Travis County Commissioners Court Agenda Request

Meeting Date: January 15, 2013

In Basic Development Permit Application #12-1748, Lake Travis ISD proposes to develop a 32.46 acre tract at 4932 Bee Creek Road, in the City of Lakeway ETJ, to construct the New Middle School, including associated drives, sports fields, utilities, water quality controls, and detention structures. The proposal is subject to the development permitting requirements of Travis County and City of Lakeway. The tract for the school site generally wraps around the top of a hill with steep slopes facing west and downhill to a tributary of Bee Creek. Approximately 27% of the site has slopes greater than 15%. The site consists of mixed grasses and dense wooded areas adjacent to a horse farm. The applicant requests two variances to allow the preferred development configuration in spite of the topographic challenges of the site. The applicant also requests a variance from fiscal security requirements.

VARIANCE REQUESTS FROM LAKE TRAVIS INDEPENDENT SCHOOL DISTRICT PERMIT APPLICATION #12-1748

WATERWAY SETBACK DIAGRAM

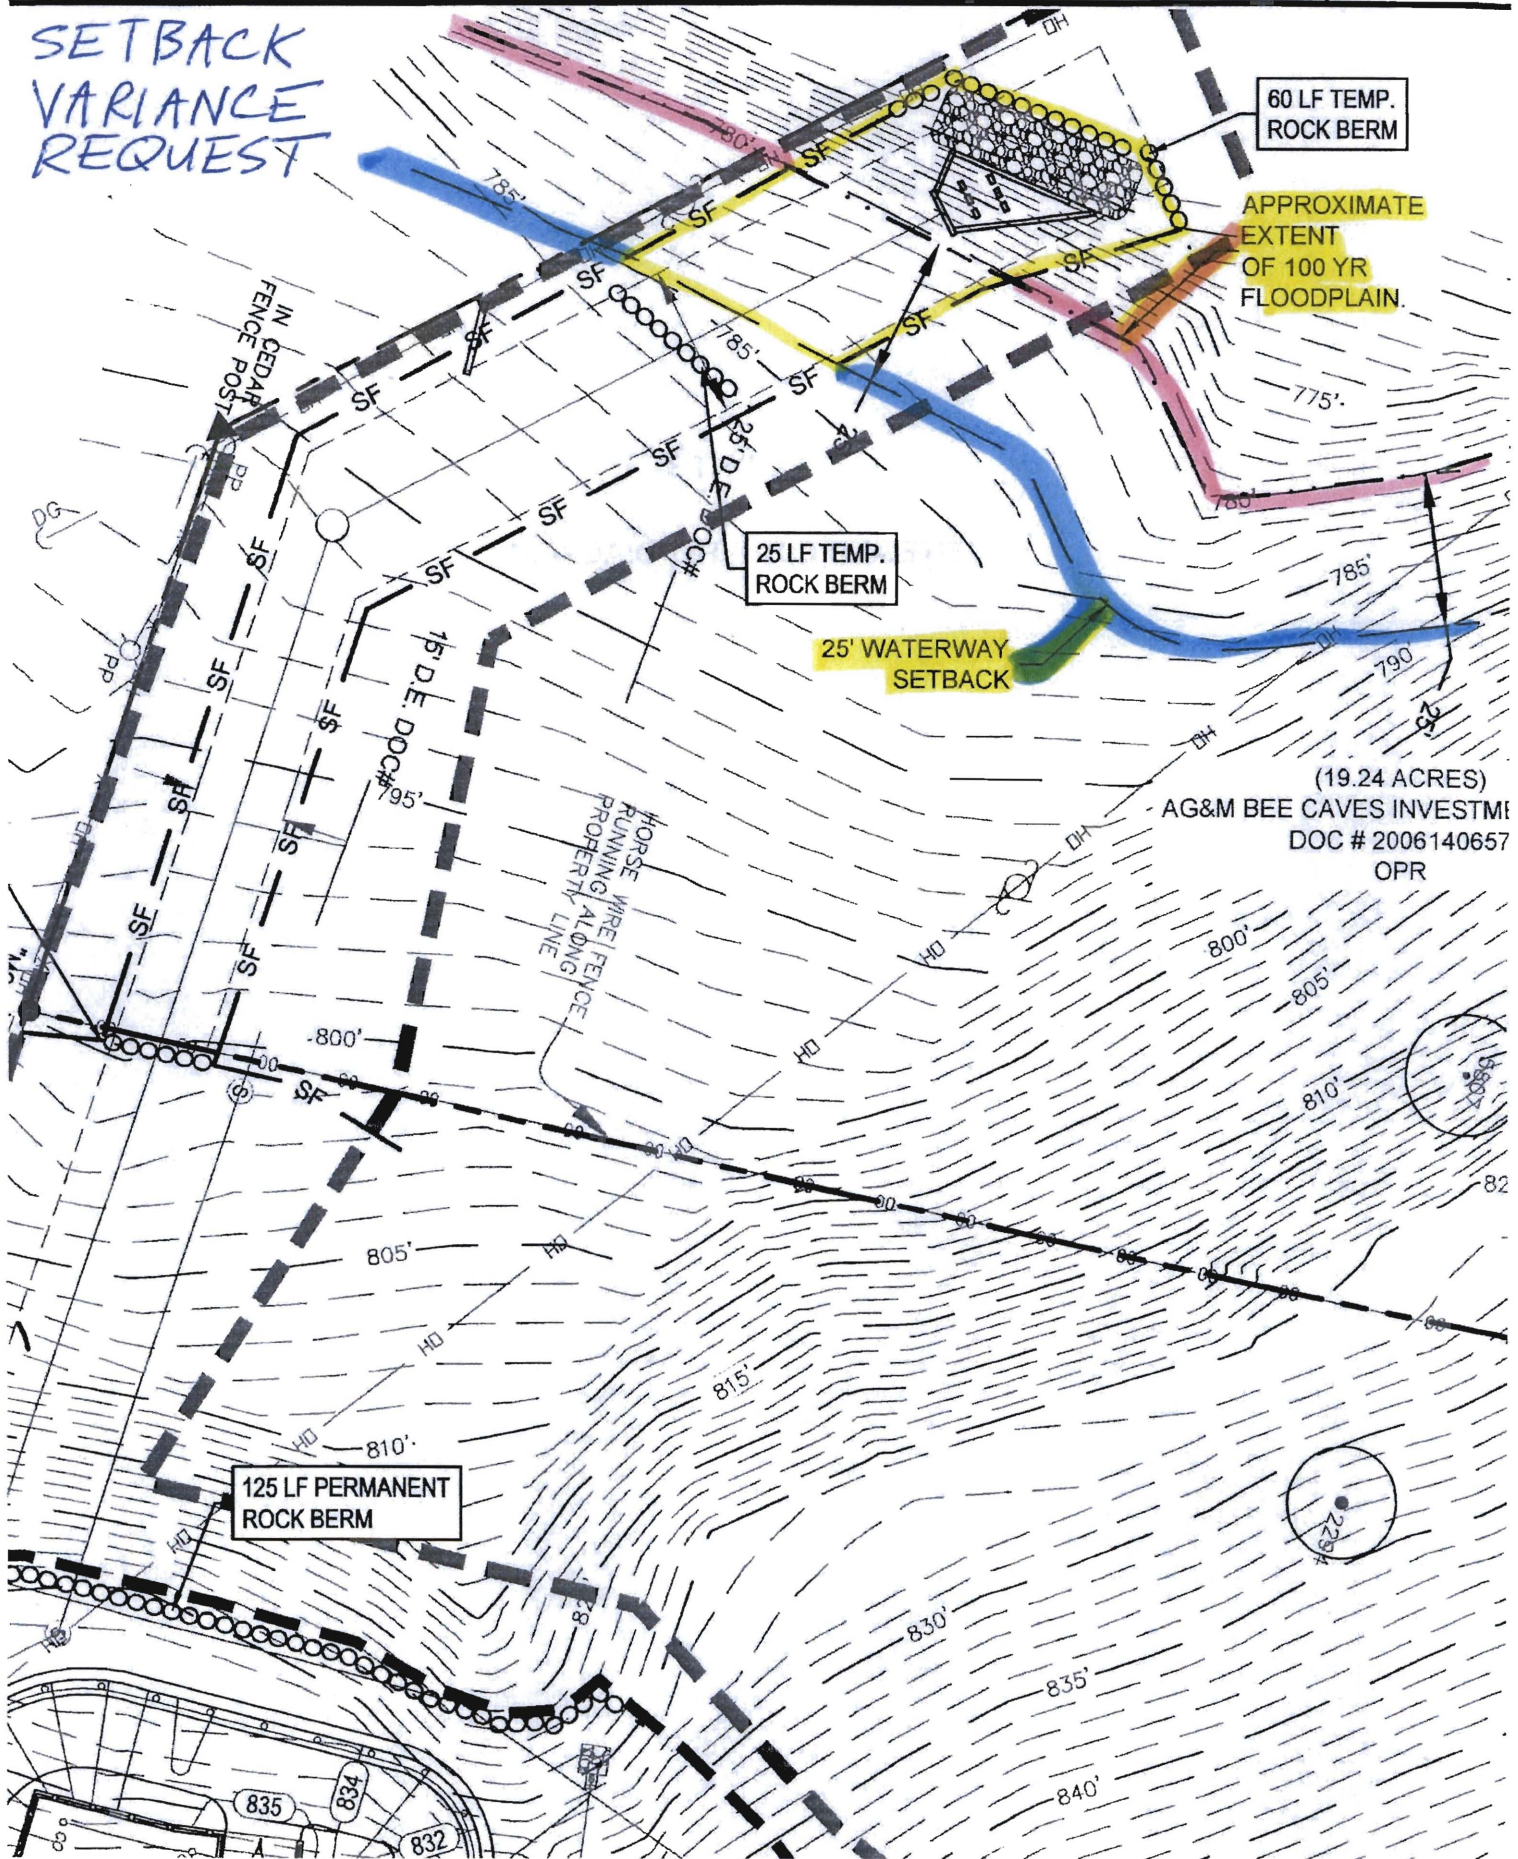
Variance A would allow construction of a storm sewer outlet headwall within the waterway setback of a tributary of Bee Creek. Section 82.941(h)(1)(B)((i) of the Travis County Code requires a setback of 25 feet from the 100-year floodplain boundary of a waterway. Section 82.941(i) requires that setbacks shall remain free of construction, development, and other alterations. Section 82.941(i) also requires that drainage patterns from development be dispersed into sheet flow before reaching the setback area.

Based on the topography of the project site and the required layout of the school building and water quality ponds, it would be impractical to attempt to discharge the splitter box bypass flow from Water Quality Pond #1 as sheet flow to existing grade onsite. The peak flows from this splitter box are approximately 85 cfs and 115 cfs in the 25 and 100-year storm events. The existing natural topography between WQ Pond #1 and the school property line is marked by bands of very steep (>35%) slopes consisting of limestone ledges with poor soil and heavy juniper growth. An attempt to disperse the splitter box bypass as sheet flow at the head of such slopes would lead to additional site disturbance in the construction of a long flow spreader which would likely not completely prevent long term erosion on these steep slopes.

In addition, the downgradient property owner (Architectural Granite and Marble) has expressed a desire that he not receive these flows distributed along the length of the joint property line but would prefer to receive these flows as a point discharge which can be more conveniently conveyed to the existing waterway on his property. For this reason, the Water Quality Pond #1 splitter box bypass flow is designed to be conveyed via enclosed storm sewer directly to an existing unnamed tributary of Bee Creek located on the adjacent property.

The attached storm sewer plan shows the proposed alignment of the storm sewer line and the proposed headwall construction within the Waterway Setback (indicated thereon as a 25' setback from the approximate 100-yr floodplain). Our design entails the construction of a 36" concrete headwall/stilling basin at the base of the existing stream bank with a large rock splash pad in the stream bottom. We've estimated the cost to construct this headwall/stilling basin at approximately \$12,000, the large rock splash pad at \$1500, and additional 36" storm sewer line constructed within the waterway setback at approximately \$12,500 for a total estimated cost for the work within the setback at \$26,000.

1. Discharging this large amount of storm water outside of the Waterway Setback would require the construction of a large flow spreader set back a minimum of 25' from the top of the stream bank. In this area, the stream bank is a mix of old alluvial deposits and severely weathered limestone and caliche, which is prone to erosion. Assuming that it was feasible to distribute the storm sewer discharge as sheet flow (less than 2" depth to minimize erosion in this erosion prone material), the weir flow equation gives a required weir length of 563' long for the 115 cfs in the design storm. In addition to a concrete flume/weir, a loose rock splash pad would also be necessary along the length of the spreader. At an estimated \$75/lf for a concrete flume/flow spreader, this would be approximately \$42,225 in addition to the cost of the proposed headwall/stilling basin (\$12,000) for a total estimated cost of \$54,225. Since the location of this flow spreader would be on an adjacent property owner (not LTISD property), it is likely that there would be additional unknown costs/hardships involved to procure the necessary easement/property to contain the required flow spreader. It is also probable that despite attempts to spread the flows out, the continual discharge of flows directly at the top of this bank will lead to severe erosion of this stream bank.

2. By discharging directly to the stream bed in lieu of constructing a long flow spreader as required to distribute this large amount of flow outside the Waterway Setback, the proposed plan will minimize the long term maintenance otherwise needed to ensure the design functionality.

3. The proposed construction of the storm sewer outlet headwall within the Waterway setback includes the placement of large rock dissipaters (12"-15" in size) at the lip of the headwall. Field reconnaissance indicates the existing stream bed in this area is bedrock, which would negate the need for rock dissipaters. We are proposing the use of flowable backfill behind the proposed headwall and over the proposed section of the storm sewer built within the waterway setback. Silt fence will be used around the perimeter of construction, a temporary rock berm placed at the headwall within the setback, and temporary rock berms will be placed at intervals along the length of the storm sewer construction from the headwall up to the pond splitter box. Construction will proceed from the lower end at the creek bank up to the pond splitter box. As individual sections of line are backfilled, the surface shall be restored with seeding and soil blankets as soon as practicable and the temporary rock berms relocated up the hill to act as a temporary BMP for the next section of line under construction.

Staff recommend approval of Variance A. Lake Travis ISD proposes placement of a storm sewer outlet headwall within the waterway setback in a drainage easement granted by the adjacent property owner (See Exhibit 2). Staff agrees with the applicant that the encroachment into the setback would allow for more certain compliance with Section 82.941(i) at significantly less cost while significantly dissipating the velocity and energy of the flow at the outlet point. While the variance is caused by the method chosen by the applicant, the staff believe the location of the storm sewer outlet below the steep slope will achieve greater environmental protection and reduces the probability of soil erosion and harmful environmental consequences than if the storm sewer discharged above the steep slope and outside of the waterway setback. Staff also have determined that the applicant's variance request is a method that makes minimal alteration of the waterway setback area (affected area equals 1821 sq. ft. or 0.041 acre), includes sufficient erosion and stabilization controls while construction of the storm sewer occurs.

SITE AND CUT & FILL DIAGRAM

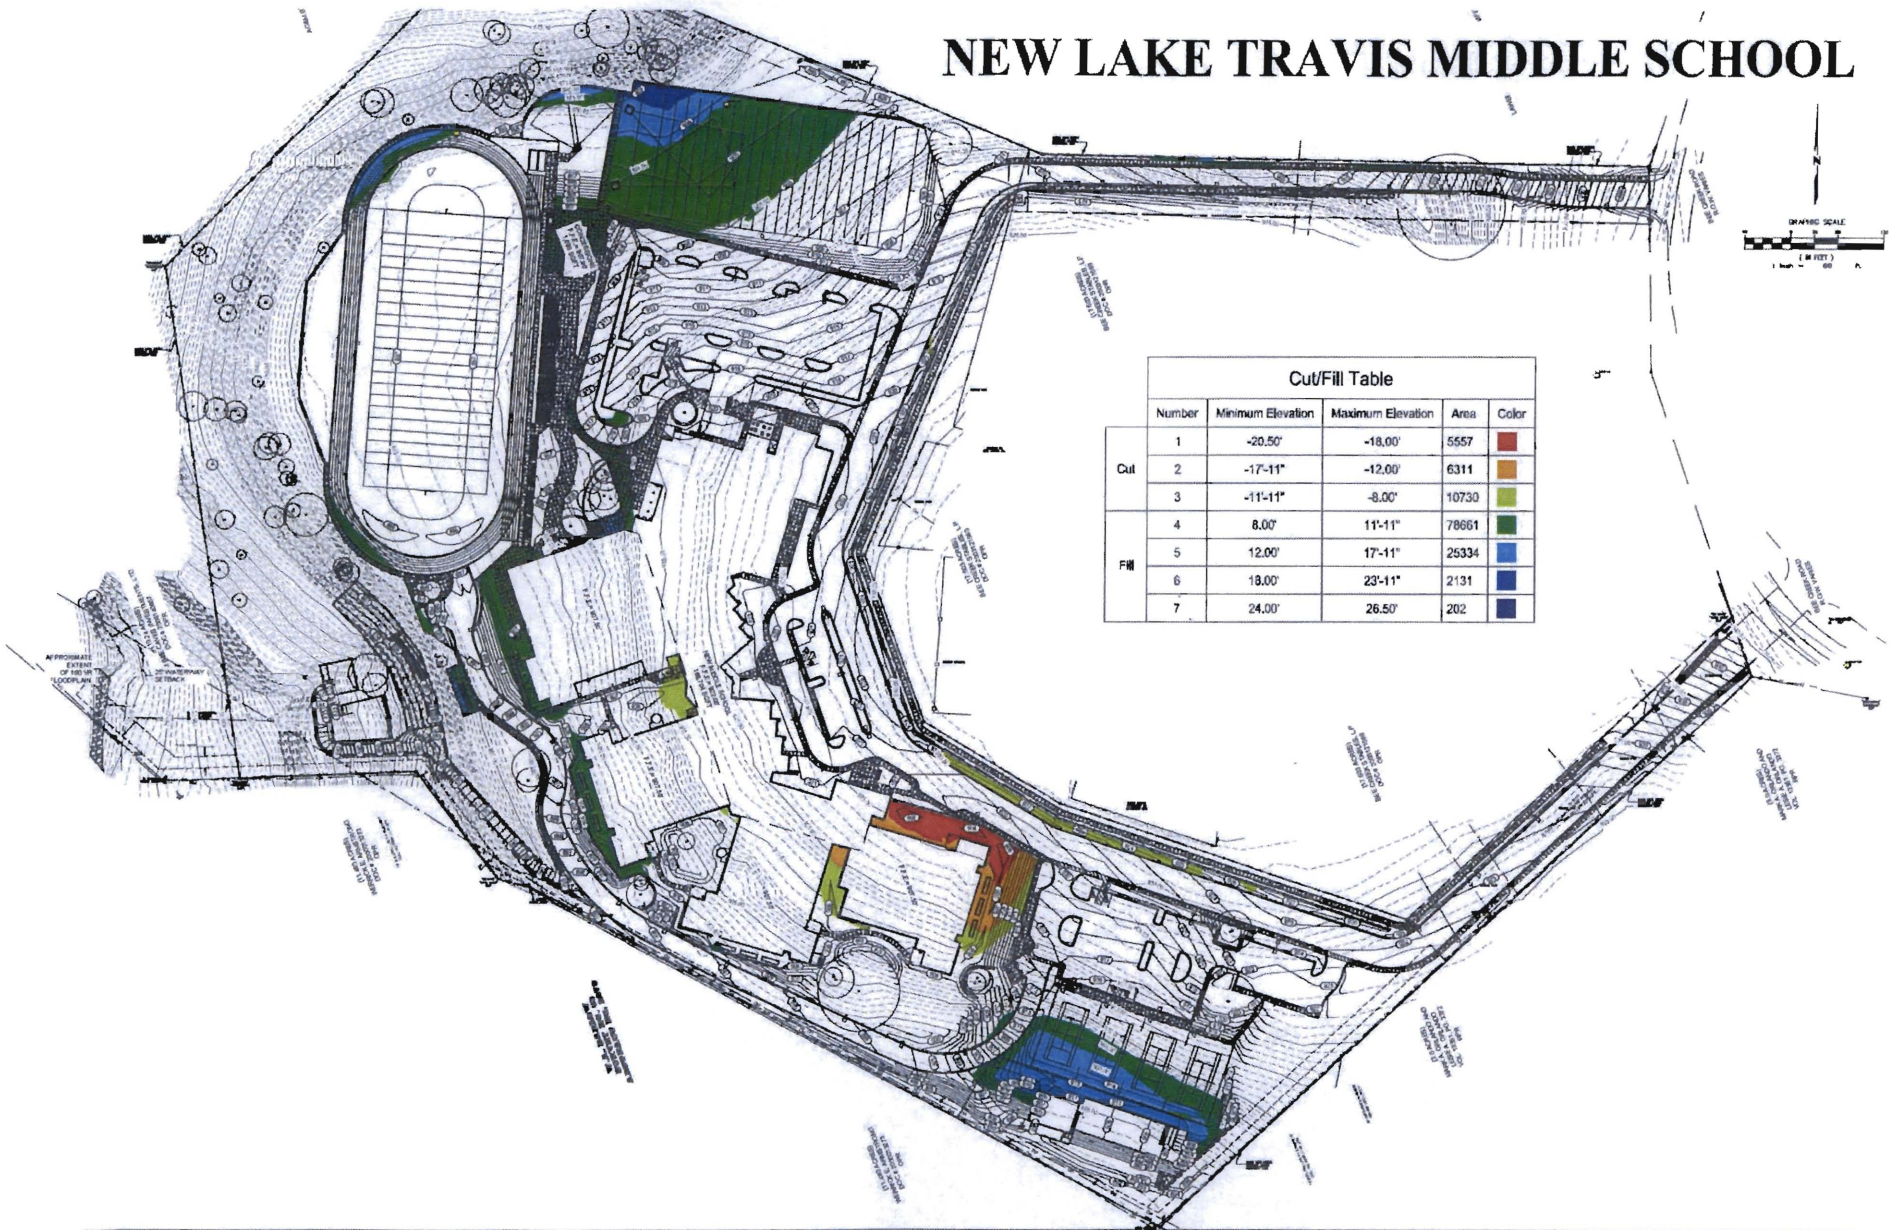
Variance B would allow land grading changes including excavations ("cuts") and placement of fill material to exceed eight feet of elevation change, in order to construct the school and associated structures on this site. Section 82.943(a)(1) of the Travis County Code specifies that all cut and fill land balancing is limited to a maximum of eight vertical feet.

The slopes of the existing topography are such that retaining walls, cuts, and fills in excess of 8 feet will be necessary at several locations to allow for the adequate and efficient use of the proposed facilities, and to satisfy maximum slope requirements for handicapped accessibility and parking, as well as passenger, bus, fire, and emergency vehicle access drives. In an effort to minimize cut and fill, the building was designed with split levels to better adapt to the topography, with the main entrance and associated parking being at the higher level and the other amenities at the lower level.

The attached exhibit shows the proposed site and grading plan and delineates in different colors cut/fill areas ranging from 8' to 11'-11", 12' to 17'-11", 18' to 23'-11", and 24' and greater.

2. It is not feasible to fully comply with the requirements of Sec. 82.943(a) while accommodating all of the educational programs and athletic functions required for a middle school. At a minimum, full compliance would require the elimination of the practice and competition fields (areas 'A', 'B', 'C' and 'D') due to the size of their respective footprints, and the natural topography in these areas.

- (a) The fill over 8' could be eliminated at the chiller and fire turnaround area (area 'E') by lowering the fire department access drive by approximately 8 feet. However, this would require 8' higher structural concrete walls adjacent to the building and problematic fire/emergency access to the competition field. The added cost of the higher concrete retaining walls adjacent to the building would be partially offset by the lower cost of the limestone block walls around the chiller. Based on the length of the walls involved, the estimated wall height of 8', and an estimated cost of \$18/sf for limestone block wall along the fire lane vs. \$30/sf for the structural concrete walls adjacent to the building, we estimate this cost at \$52,320.

- (b) The fills over 8' at the rear of the building (areas 'F', 'G', and 'H') could be reduced but would require extensive handicap compliant ramps to get down from the building exits. Based on

lowering these areas by 4', three 48' long ramps with hand railing would be required at an estimated cost of \$8,160/ramp or \$24,480 total. The costs of these ramps would be offset by concrete and block wall heights reduced by 4' in these areas with an estimated savings of \$49,200. We estimate the net cost of this change at (\$24,720). Although in theory there may be a potential cost savings by reducing the fill in these areas, in practice there is little space available at in areas 'G' and 'H' for ramps.

- (c) The cuts over 8' next to the building (areas 'I', and 'J') could be eliminated but would require substantial waterproofing and subsurface drainage of the building exterior walls in these locations at an estimated cost of \$25,000. The building would also require extensive redesign at area 'J' as this is a point of emergency ingress/egress. It is unknown the magnitude of this cost.

- (d) The fill over 8' for the tennis courts (area 'K') could be eliminated with the construction of an 8' high, 260' long concrete retaining wall and a 96' long handicap ramp complex between the tennis courts and the adjacent parking lot. We estimate the cost of this wall and ramp complex at approximately \$82,120. However, lowering the tennis courts would reduce the available depth in the adjacent water quality pond which would require this pond to occupy a larger footprint to attain the necessary water quality volume. We estimate the footprint for this pond would be approximately 60% larger than the current design and would cost an additional \$75,000. We estimate the total cost to lower the tennis courts at approximately \$160,000.

- (e) Elimination of the cut over 8' for the main entry drive (area 'L') along the building front would require raising this drive by approximately 4'. This would reduce the wall height of the limestone block wall adjacent to the property line and require higher concrete retaining walls adjacent to area 'J' and additional walls/handicap ramps next to the building's main entrance. We estimate the additional wall cost at \$21,600 and the additional ramp at \$8,160 for a total of \$29,760.

4. The total area involved in this variance request is approximately 0.519 acres of cut and 2.441 acres of fill. These areas are broken down on the attached exhibit accompanying this variance request.

5. The proposed cut/fill areas located on slopes with a gradient of more than 15% will be contained by structural retaining walls. These walls will act to armor the faces of the cut slopes in the cut areas

and the embankment materials in the fill areas and protect these cut/fill slopes from erosion. This degree of erosion protection is the same regardless of whether the wall height is less than or more than 8'. The embankment adjacent to the tennis courts will be placed with a final design slope of 4:1 and will be finished with solid grass sod. Finally, permanent rock berms will be placed downgradient from the perimeter walls at the practice field (areas 'A' and 'B'), the competition field (areas 'D' and 'E') and the tennis courts (area 'K').

Staff recommend approval of Variance B. Lake Travis ISD proposes placement of land balancing cuts totaling 0.519 acres and fill placement totaling 2.441 acres. Exhibit 3 shows the specific locations proposed for the cut/fill. Staff agrees with the applicant that cuts and fills exceeding eight feet are important in order for design a functional site that provides educational services on this topographically challenging location. Without the variance, all athletic functions would not be possible and the practice and competition fields would need to be limited due to the topography. The applicant notes that the amount of cut/fill is minimized due to the school design of a split level building, use of terraced retaining walls, and placement of 73% of the facility on slopes of less than 15%, more closely following the natural terrain.

The potential environmental impact of the cut/fill is mitigated by the applicant. First, TNR is requiring a detailed sequence of construction to limit the runoff impacts from disturbed land. Secondly, use of reinforced concrete, engineered retaining walls on the site will contain fill and armor the faces of the cut slopes in the cut areas and the embankment materials in the fill areas. Also, certain steep slopes will be sodded with solid grass or will use permanent rock berms. These measures will provide for an equivalent level of environmental protection when compared to shallower cut/fill and the proposal does not create a significant probability of environmental harm.
